## **SELWYN DISTRICT COUNCIL**

### **Solar Glare Report Review For Proposed Brookside Solar Farm**

**Date: 23 Sept 2022**

**Velden Aviation Consulting Ltd**

Relative positions of visual references. The Boffa Miskell Visual Simulation Report Viewpoints are considered here.

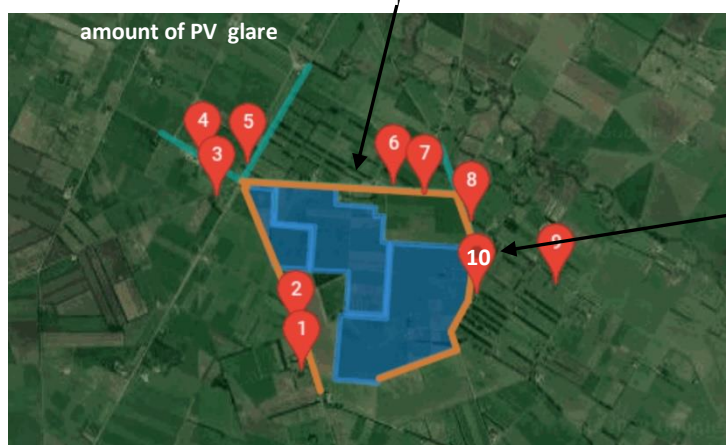
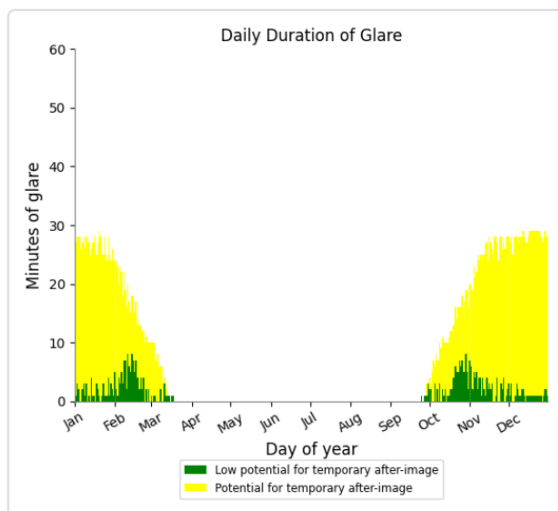
The Boffa Miskell Visual simulation viewpoint 3 proposes planting along this road.

The Boffa Miskell Visual simulation Viewpoint 4 proposes planting along this road.

The Boffa Miskell Visual simulation Viewpoint 2 proposes planting along this road.

The above visual references illustrate areas where vegetation may be scarce and possibly need additional planting. This has however been taken into consideration by the Boffa Miskell planned vegetation plantings as detailed in their Visual Simulation report.

**Figure 5.2.** Impact of glare on Buckleys Road (R3) from Stage A PV development with no 2m high plantings (a) and with 2m high plantings (b)

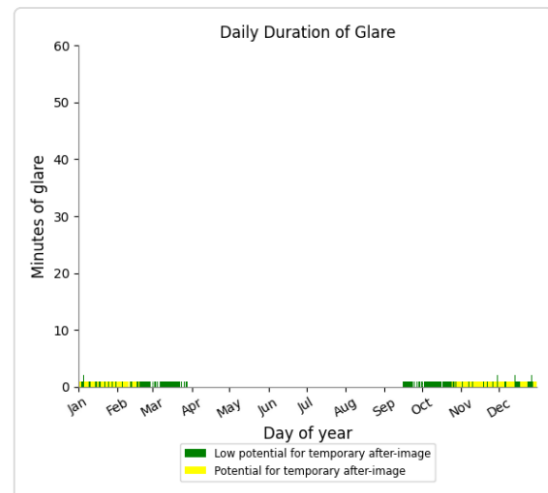
The below example shows the difference of impact on glare mitigation in having 2m high vegetation on the side of the road and not having it.

Simulations of the 2m obstruction surrounding the Brookside Solar farm indicate that the Boffa Miskell planned plantings as per their Visual Simulations should be effective in significantly reducing any remaining glare.

### Pager Power Dwelling 1 Results

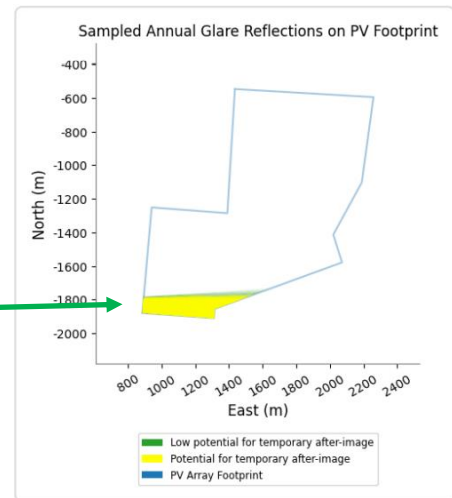
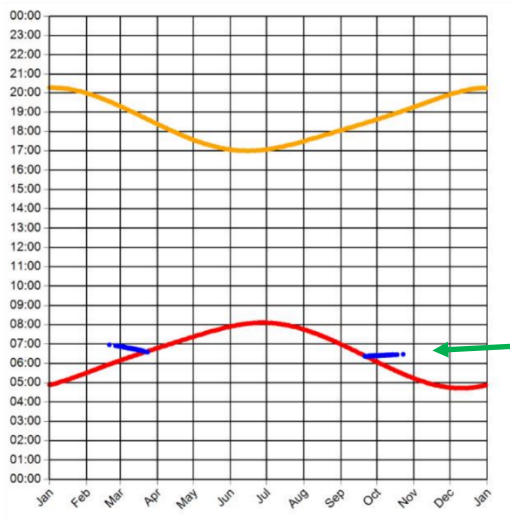
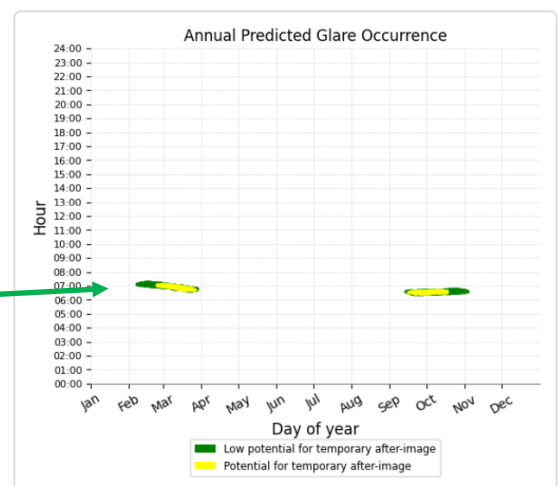
Pager Power period of glare from mid-Feb to mid-March and mid-Sept to mid-Oct

VACL result shows same periods for yellow glare and for same time periods around 7am -6 am

The results above show good agreement between both the Pager Power study and the independent analysis by VACL.

The reflection area has the same footprint for both for both Pager Power diagram for the whole Brookside Farm area and the Stage C area and also the same time frames for predicted glare occurrence.

## Pager Power Observer 4 Results

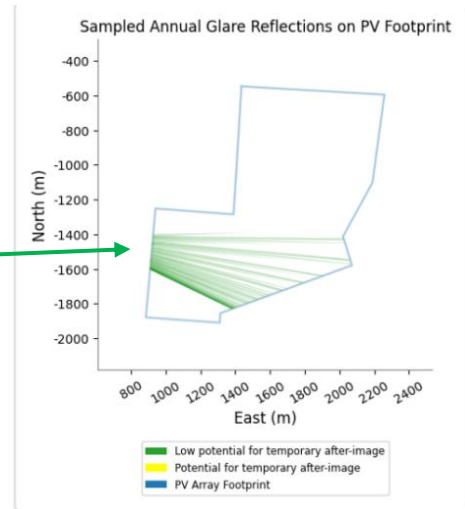
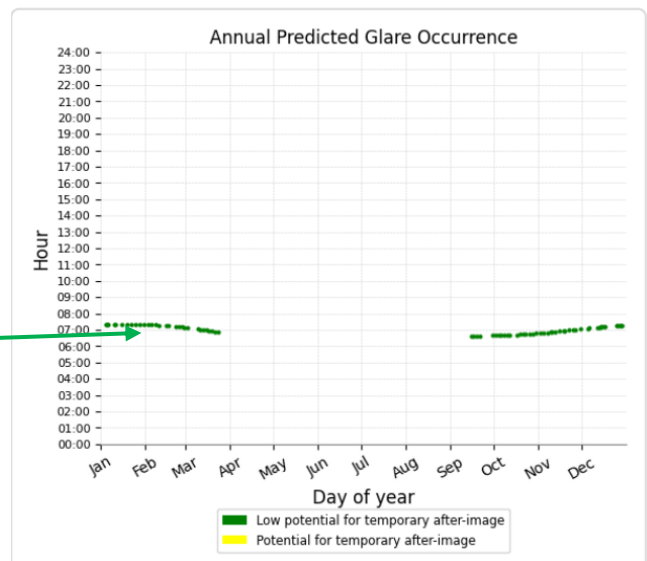
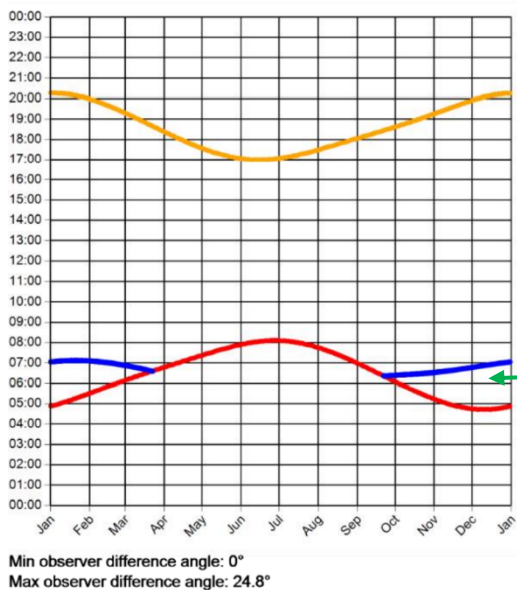
Brookside Solar farm outline in red gives the same reflection footprint as Stage 3 area outline in green in VACL model.

The results for Observer 4 (Dwelling 4) above show good agreement between both the Pager Power study and the independent analysis by VACL.

## Stage A Array and R3

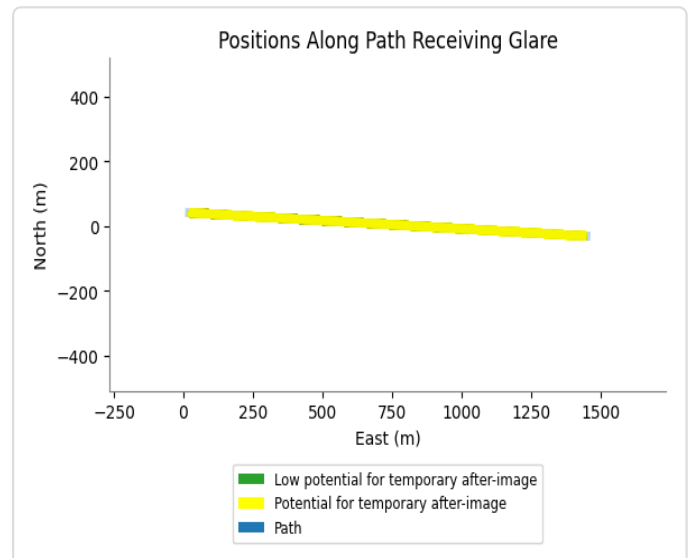
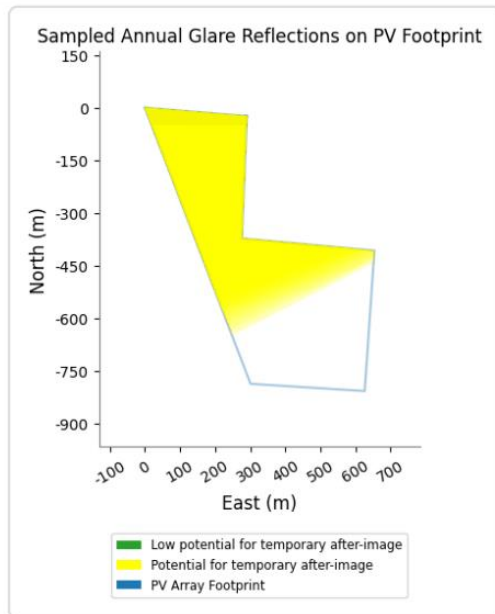
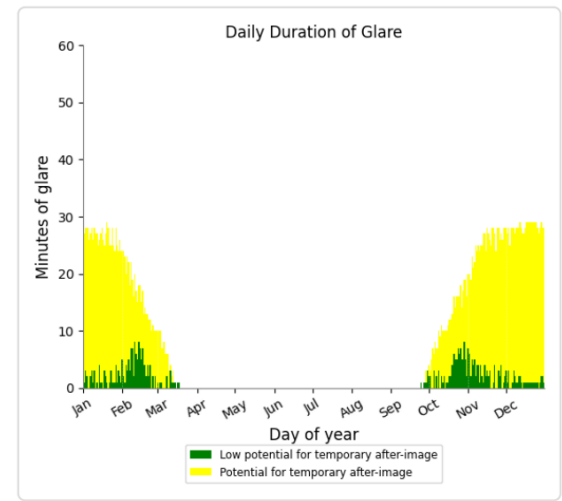
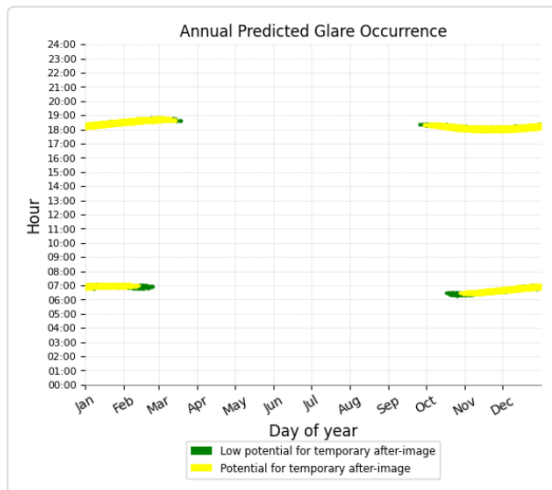
**Impact on Traffic:** Glare mainly in morning around 7 am for easterly moving traffic of and around 6pm for westerly moving traffic, duration <30 mins. Glare impact is expected from October through to early March.

## Stage B Array and R3

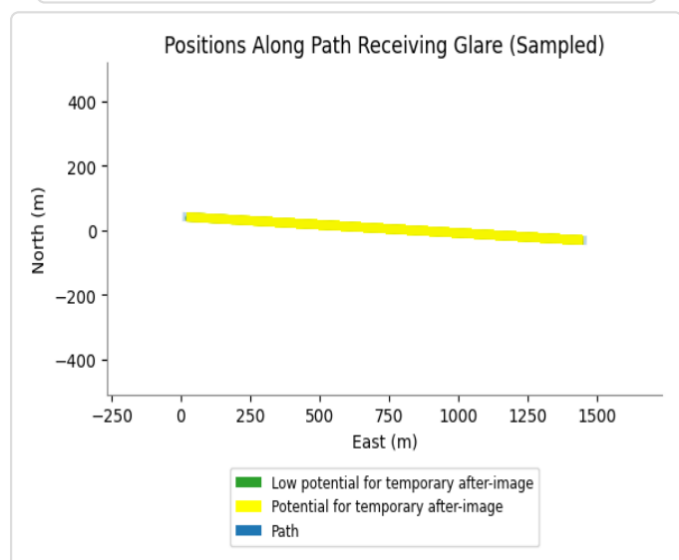
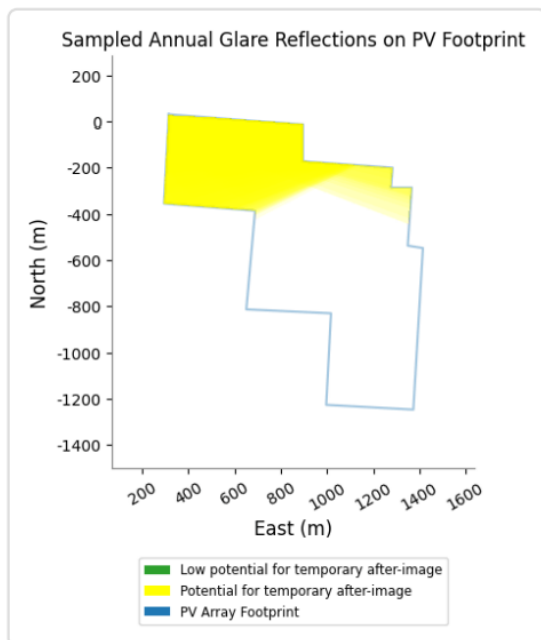
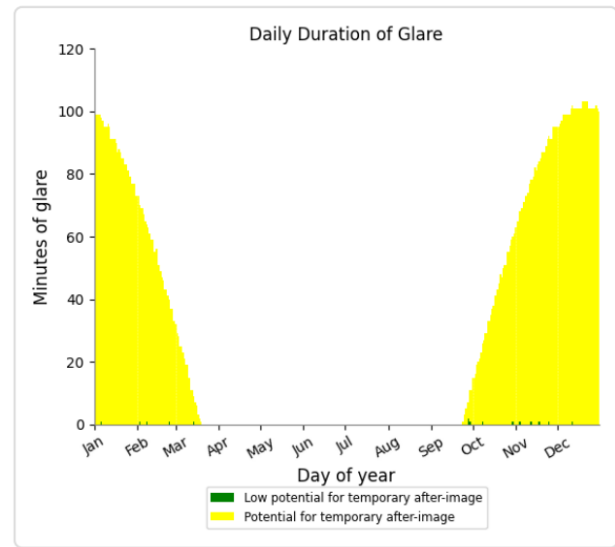
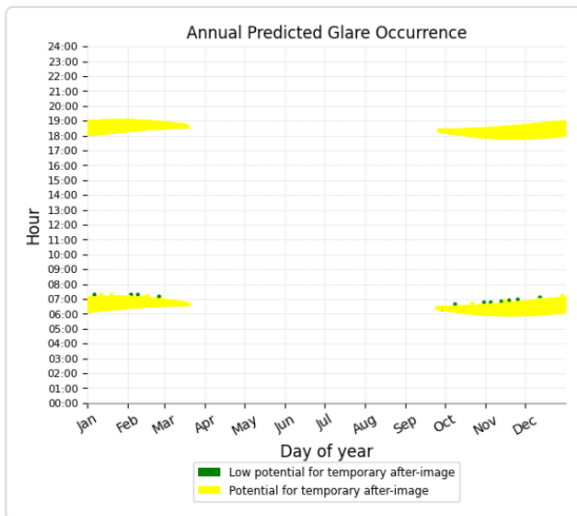
**Impact on Traffic:** Glare mainly in morning around 7 am for easterly moving traffic and in evening around 6 to 7 pm for westerly moving traffic, duration of <100 mins. Impact found all along road R3. Glare impact expected from October through to mid-March

## Stage C Array and R3

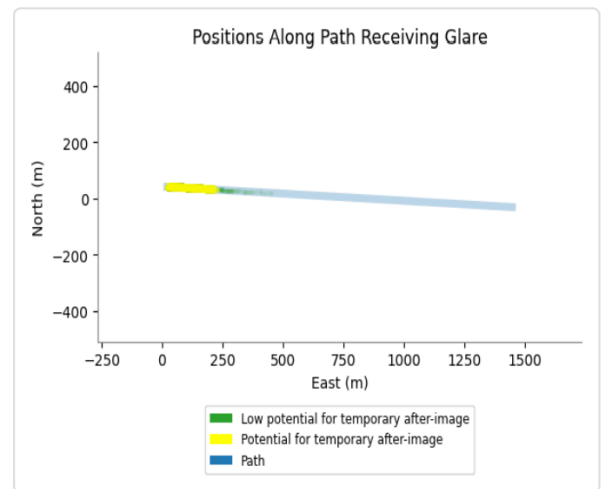
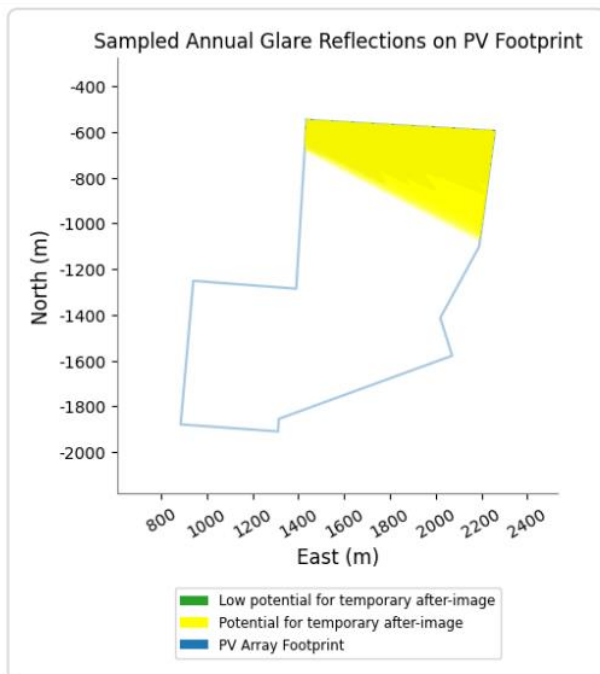
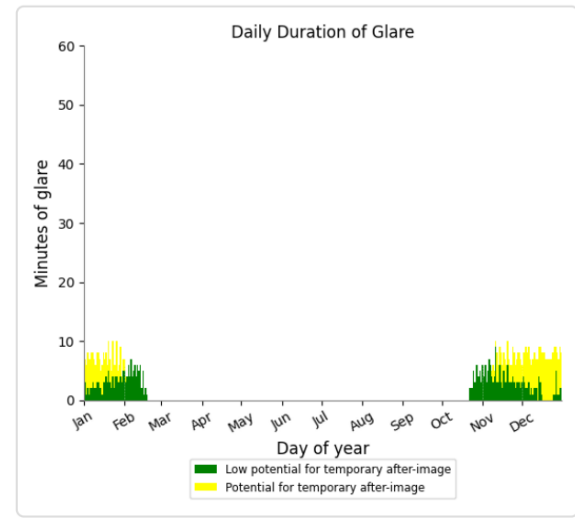
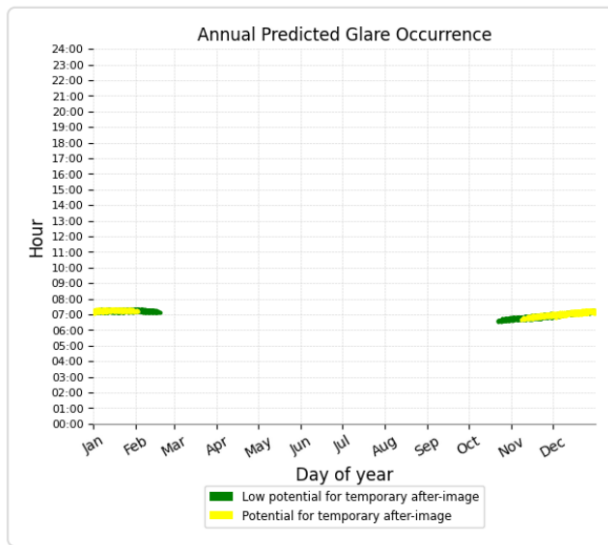
**Impact on Traffic:** Glare mainly in morning around 7 am for duration of <10mins. Impact found mainly at the junction travelling in easterly direction. Glare impact expected from mid-October through to end Feb.
